SERVICE BULLETIN

APPLICABILITY: 2010-2013 Legacy and Outback Models **NUMBER:** 07-72-13
SUBJECT: Sunroof Does Not Open or Close Properly **DATE:** 01-29-13
 Popping or Slamming Sound When Glass Lowers
 Prior To Opening

Original Cable Bracket

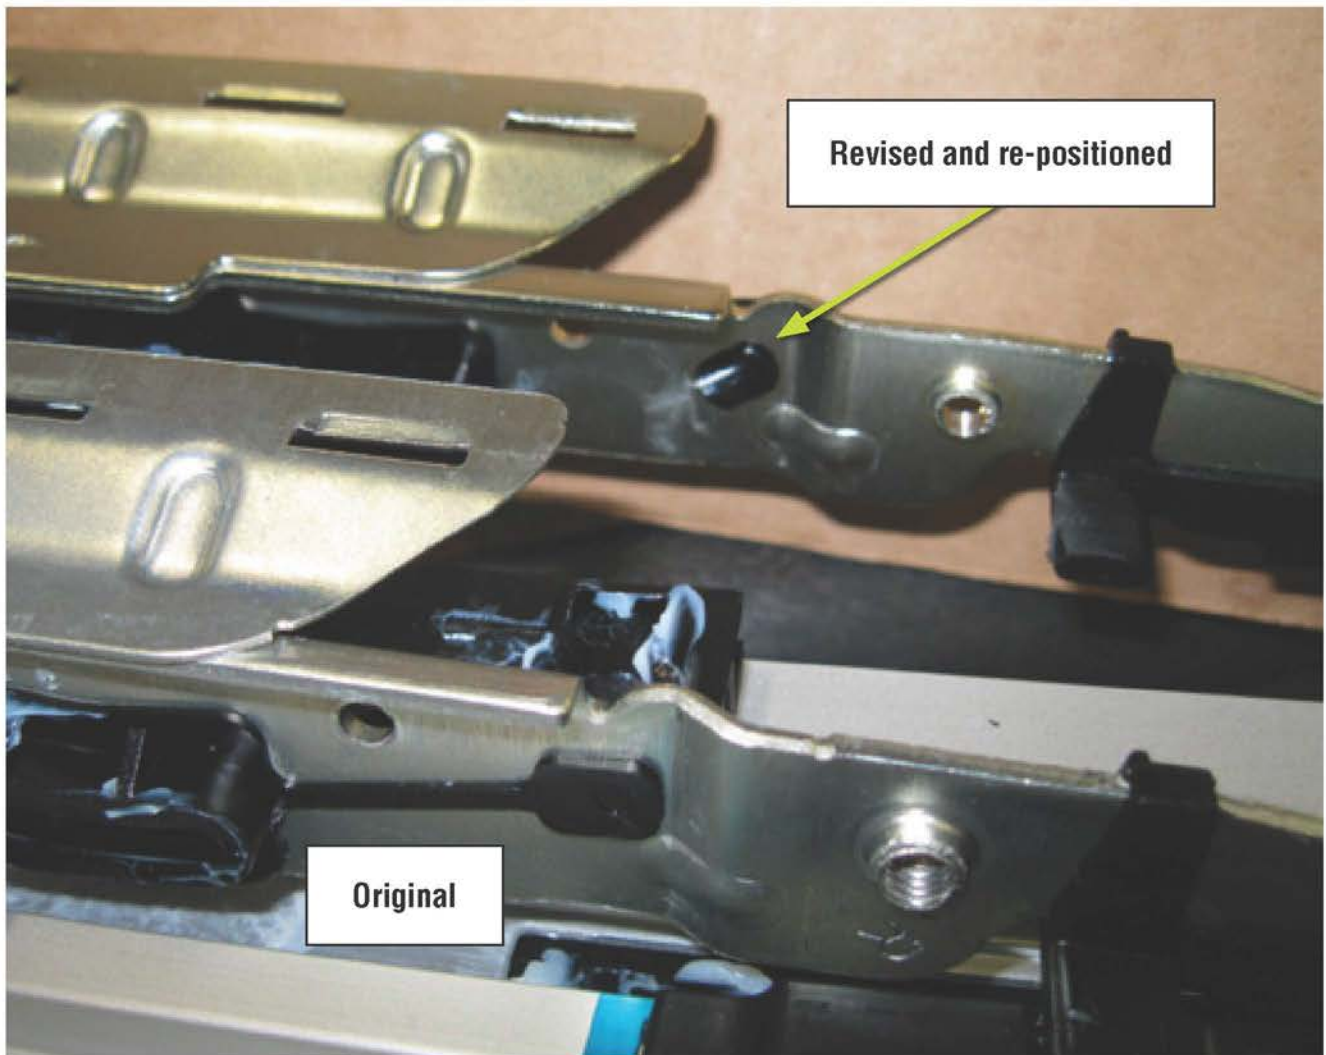
While the rail (sunroof frame) assembly remains virtually unchanged, significant revisions have been made to the cable assemblies (lid brackets) to increase their durability, rigidity and ease of operation as shown in the photos below.

The “Cable Repair Kit” consists of a revised lid bracket and sunroof operating cable assembly.

PART DESCRIPTION	NEW PART NUMBER	INTERCHANGEABILITY	OLD PART NUMBER
Repair Kit Cable RH	65449AJ00A	New to Old ONLY	
Cable Assy RH			65441AJ00A, B, D
Repair Kit Cable LH	65449AJ01A	New to Old ONLY	
Cable Assy LH			65441AJ01A, B, D
Rail Assembly	65420AJ00D	New to Old ONLY	65420AJ00A, B, C, D

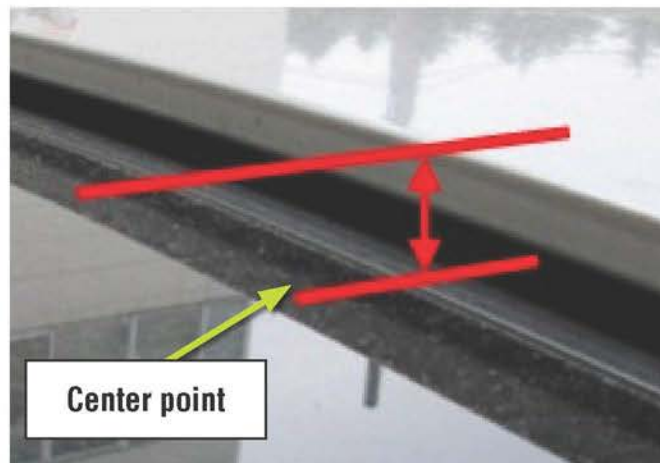
- Open the sunroof to the point where the rear edge of the glass is fully dropped down, just before it retracts under the roof panel.
 - o Determine the center point of the back edge of the glass panel by measuring from the outside edges in toward the middle from each side.
 - o Measure the distance between the top outside edge of the roof opening flange and the glass panel as shown in the photo below.

The standard values are 21.7 mm for Legacy, and 21.9 mm for Outback.

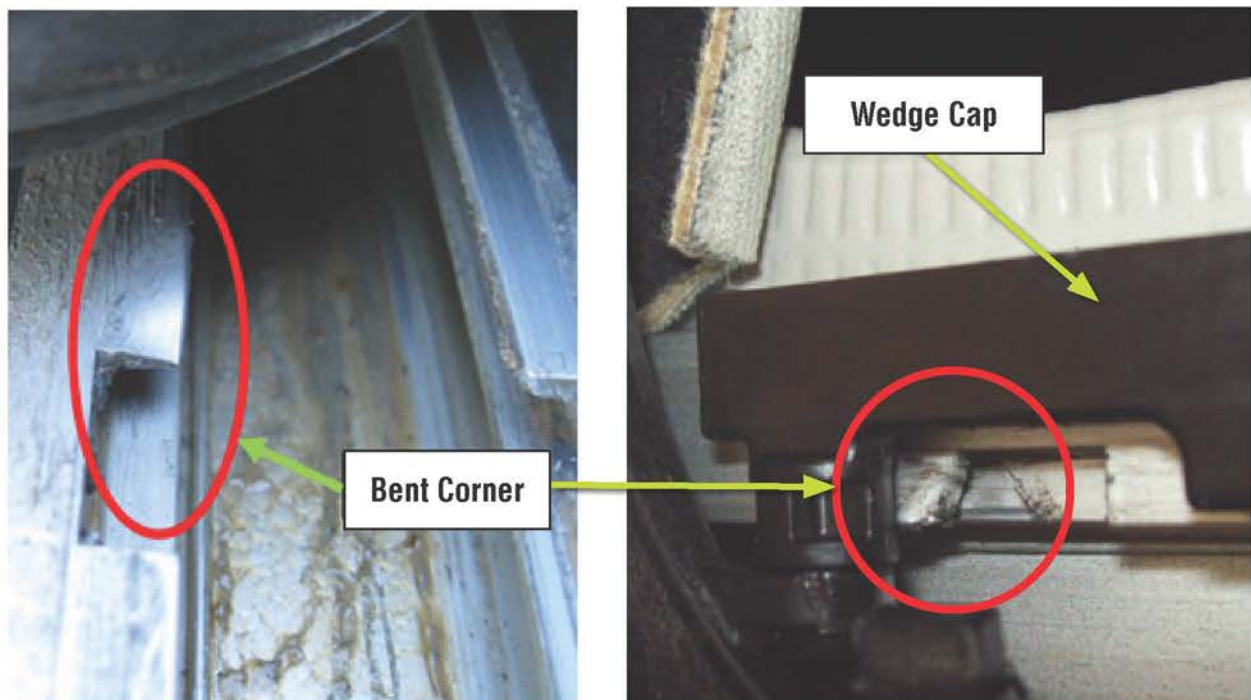
If the measurement is correct, inspect the gap from side to side and make sure it is even (one side is not higher or lower than the other). The photo below shows an Outback sunroof with the left (driver's) side of the glass panel much higher (narrow gap) than the right.

In this case, although the sunroof on this vehicle is operational, the corners of the rectangular openings in the side rails have become deformed (bent) as shown in the photos below. This keeps the lid bracket shoe from dropping into the rectangular opening in the side rail as it should. Instead, when the glass panel retracts, the lid bracket shoe rides on top of the side rail instead of inside the channel causing the condition shown in the photo above. Again, if any deformation of the rail or the wedge cap is confirmed, replacement of the rail assembly along with both cable assemblies is required.
